**MEMORANDUM**

REVIEW TYPE: Site Plan

PROJECT NAME: Fortune Parc

CASE #: 8-04015

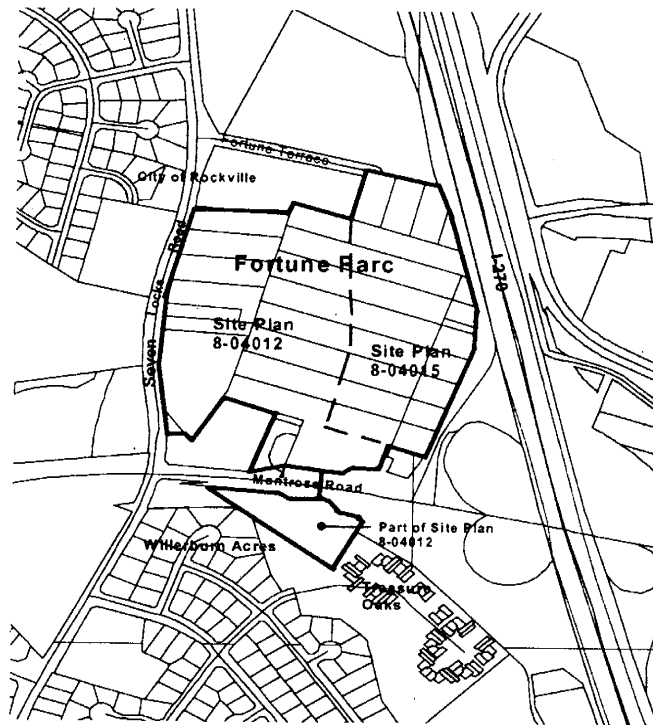
A waiver to reduce the building and parking setbacks from the property boundary at the I-270 off-ramp is being requested by the applicant. The applicant cites Section 59-C-5.4392(b)(2)(F) of the Zoning Ordinance, which provides the Planning Board the authority to approve a reduction from the required setbacks. The applicant is requesting a reduction of the required building setback from 100 feet to 85 feet and for the required parking setback from 50 feet to 35 feet between stations 541+01.93 to 541+55.95. The area within the boundaries of these station points protrudes into the site by approximately thirty feet.

The applicant has requested the waiver for a reduction of both the building and parking setbacks [See Appendix C] due to compatibility issues associated with the layout of the parking facilities and the adjacent land use. The small triangular segment of the I-270 right-of-way protrudes into the site by approximately 30 feet from the closest point of the property line to the edge of the proposed building and parking facilities. The applicant contends that to conform to the setback would change the vehicular circulation and building location. Additionally, the applicant states that all other parking facilities, circulation areas and office buildings proposed along I-270 meet or exceed the setback requirements.

M-NCPPC staff believes the small triangular portion of the right-of-way that protrudes into the site should not alter the layout of the building and parking within the station points referenced on the site plan. Staff accepts the justification offered by the applicant and has asked the applicant to increase the planting along the right-of-way to offset the reduction and provide additional screening from I-270.
